Product Category	Model(s) Affected	Date Issued
Sanitizers	IntelliChlor LT/Plus 523741,523747,523730,523735,523738,523744,523750,523733,523961, 523962,52396, 523965,523966,523967,523968,523969,523914,523963, 523744-EC,523747-EC,523735-EC	August 28, 2025
Topic		Bulletin Number
SENSOR MODULE on IntelliChlor LT/Plus SCGs		A00707

I Description

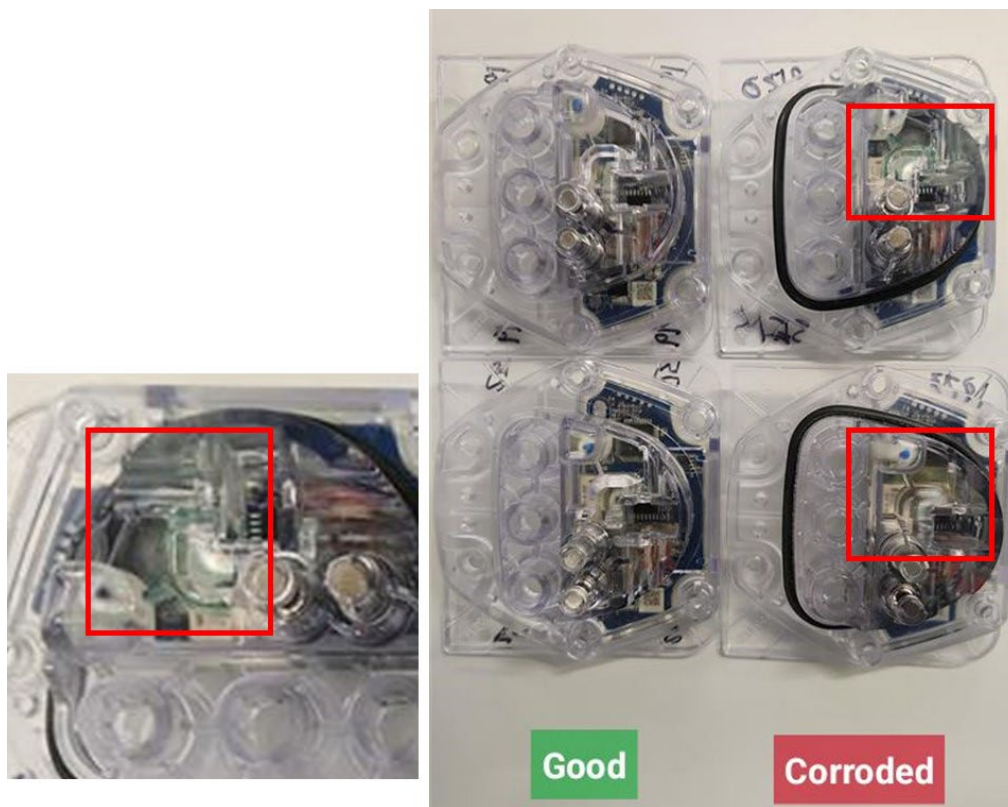
Most often, this issue can be identified with the “SENS ERR” warning message. In some less common occurrences, it could be associated with a salinity reading of 0 ppm or a “WAITING FLOW” reading in rare occasions.

The issue can be confirmed by removing the sensor pack and examining the underneath of the unit (flow switch side). If the issue is associated with the unit, you will see a discoloration of the board (from regular blue to greenish or yellowish) indicating a corrosion area affecting the performance of the board (See visuals on next page).

If you experience a “SENS ERR” issue and the system is not operating, **replace the sensor pack module using replacement part 523769** (available after 9/2/25) and follow instructions included with the replacement module.
